Town of Hilton Head Island
Design Review Board Meeting
Tuesday, April 27, 2021 – 1:15 p.m.
AGENDA

Town of Hilton Head Island
Design Review Board Meeting
March 23, 2021 at 1:15 p.m. Virtual Meeting
MEETING MINUTES

LANDSCAPE PLAN

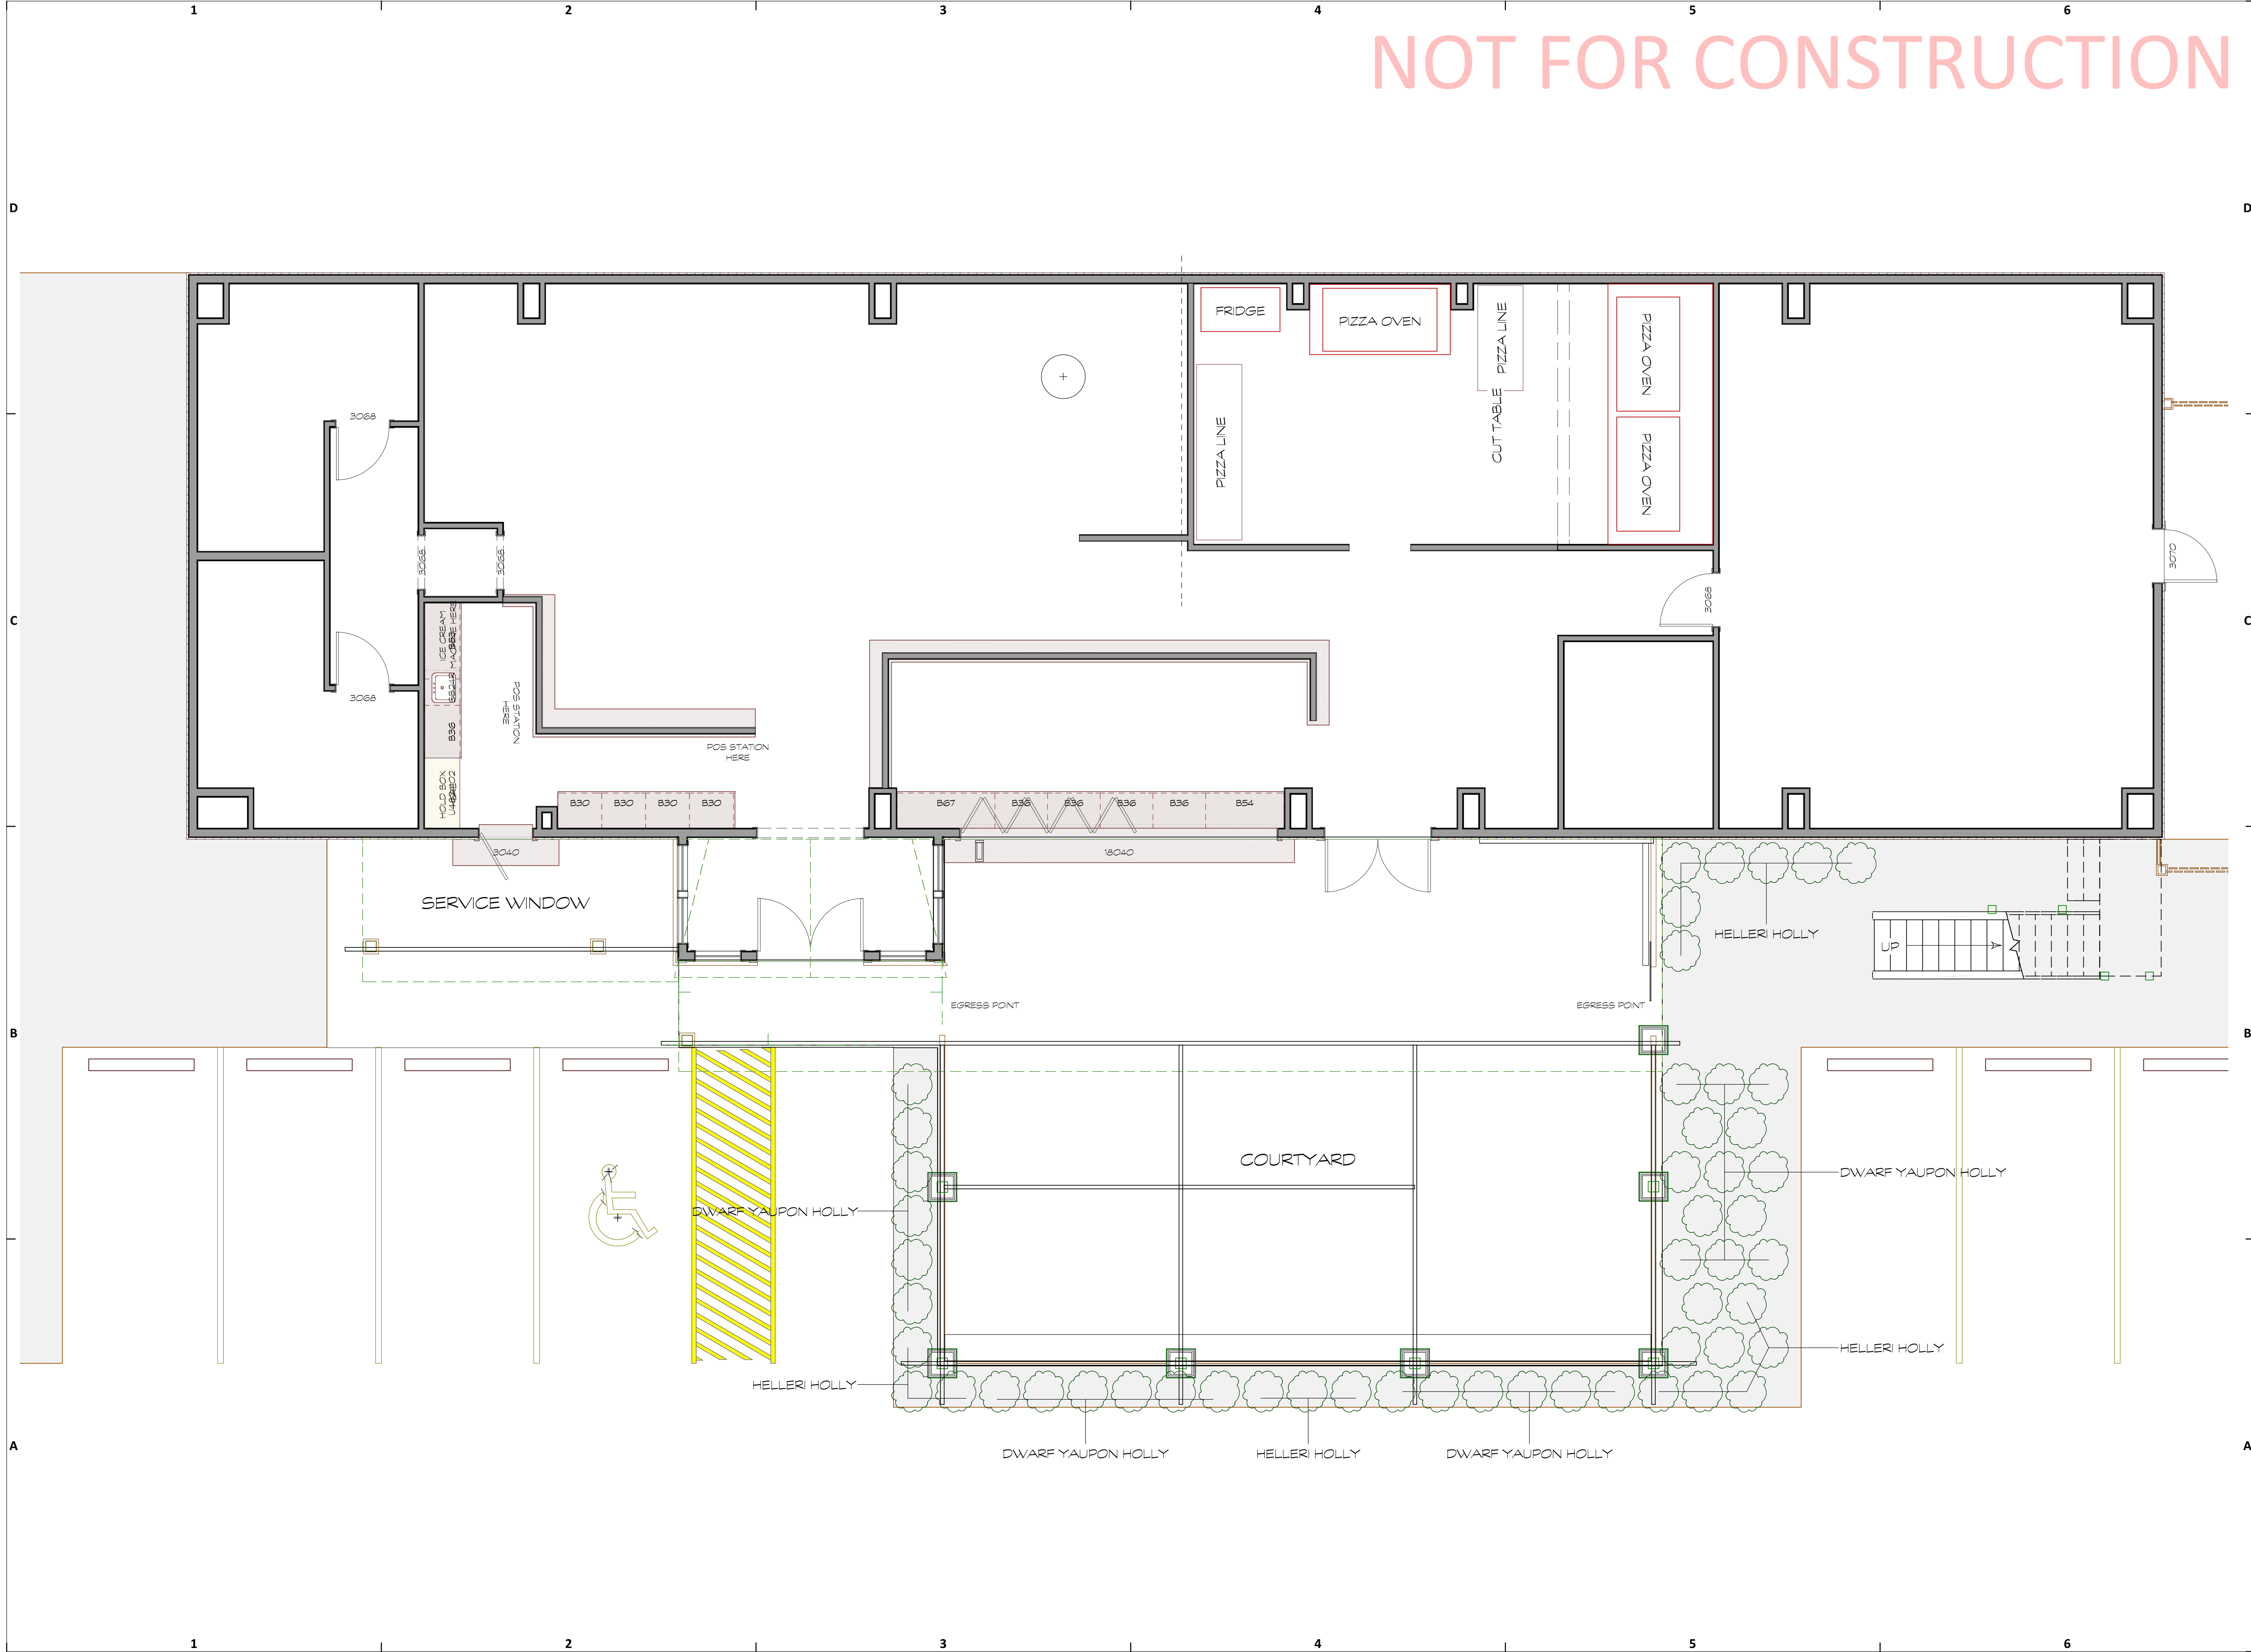
DESIGN GUIDE/LMO CRITERIA	Complies Yes	No	Not Applicable	Comments or Conditions
Location of existing trees and new trees provides street buffers, mitigation for parking lots, and an architectural complement that visually mitigates between parking lots and building(s)	<input type="checkbox"/>	<input checked="" type="checkbox"/>	<input type="checkbox"/>	Locate the existing Live Oak adjacent to the building.
Native plants or plants that have historically been prevalent on the Island are utilized	<input type="checkbox"/>	<input checked="" type="checkbox"/>	<input type="checkbox"/>	Revise the landscape plan to replace the Helleri Holly with Yaupon Holly.
A variety of sizes is selected to create a “layered” appearance for visual interest and a sense of depth	<input type="checkbox"/>	<input checked="" type="checkbox"/>	<input type="checkbox"/>	Revise the landscape plan to add Fig Vine to the exterior of the wall.

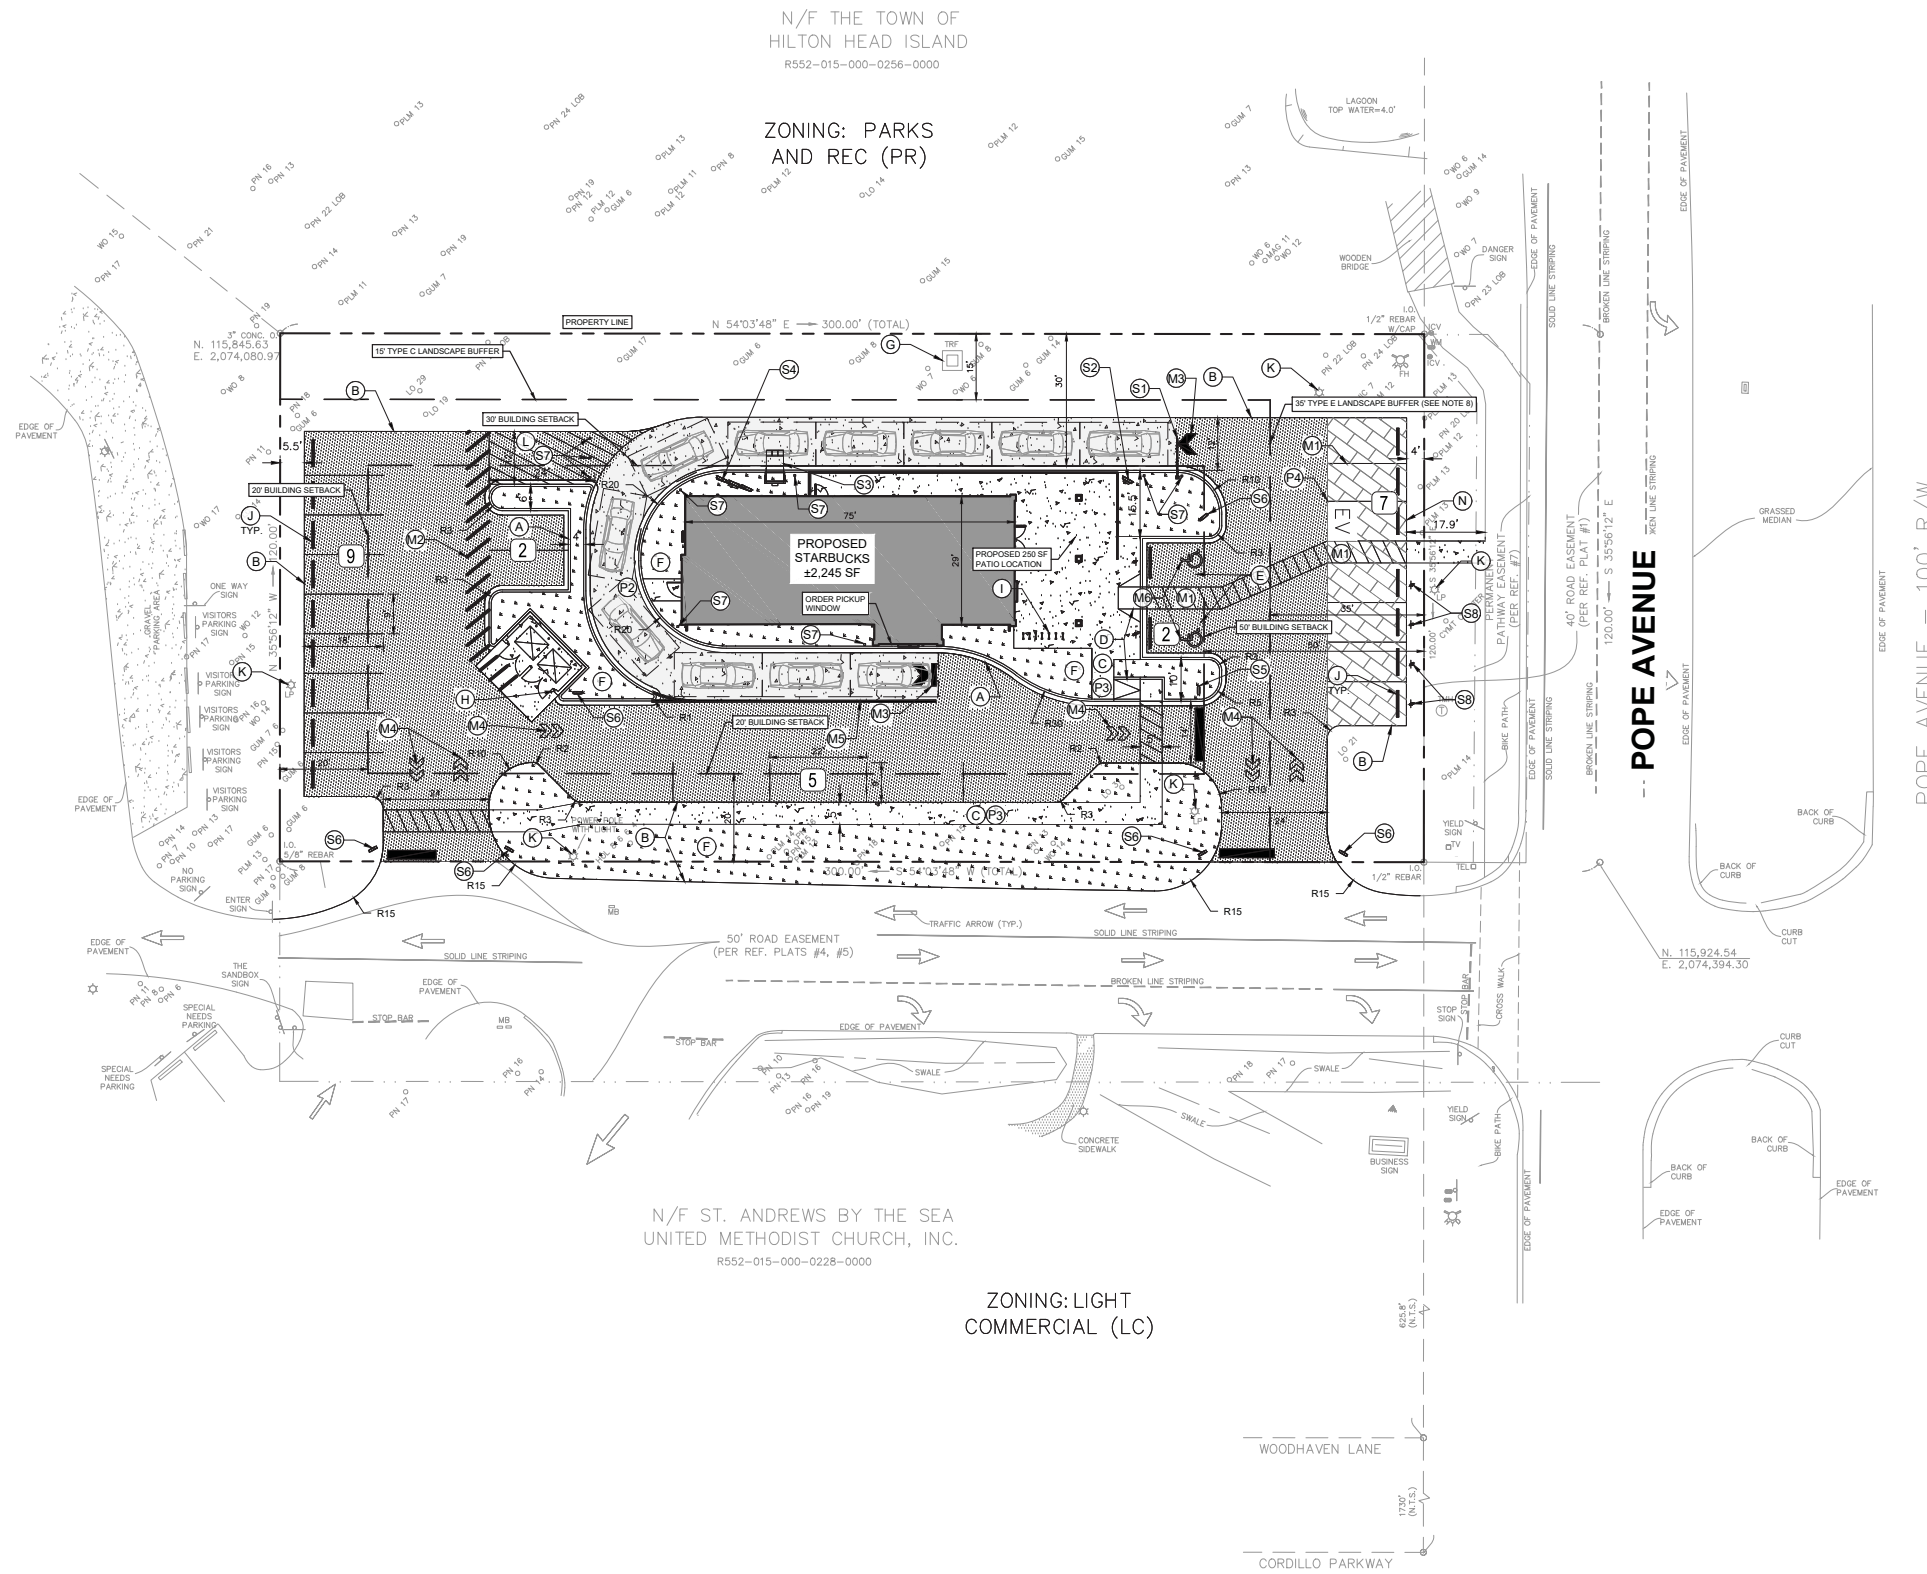
On page L101, there is a buffer chart for the Pope Avenue buffer stating it is a Class A, assuming Type A, Option 2. If the waiver is granted, the buffer chart does provide enough trees and shrubs to meet the Type A, Option 2 buffer requirements for the distance listed in the chart, however, the survey states that the property line is 120'(see sheet C301) and not the 108' listed in the chart.
